TECHNICAL SERVICE BULLETIN

3.0L EcoBoost - Buzz/Vibration/Rattle Noise Underneath Vehicle Near The Left Rear Door - Built On 25-Jan-2022 And Through 10-Mar-2022

22-2135

19 April 2022

Figure 1

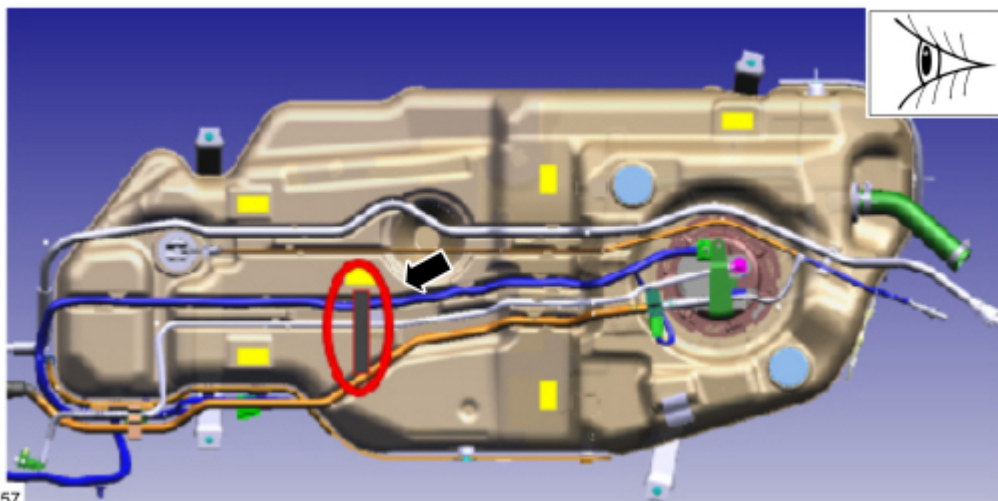
1. Remove the fuel tank. Refer to Workshop Manual (WSM), Section 310-01.
2. Clean the top of the fuel tank in the area outlined in Figures 1-2 with soapy water and/or isopropyl alcohol as needed.

3. Stack 3 Rotunda hard foam patches on top of each other.
4. Install the stack of 3 Rotunda hard foam patches in the circled area. (Figures 1-2)
5. Make sure that the fuel line convolute shown in Figure 3 is seated in the retaining clip. (Figure 3-4)
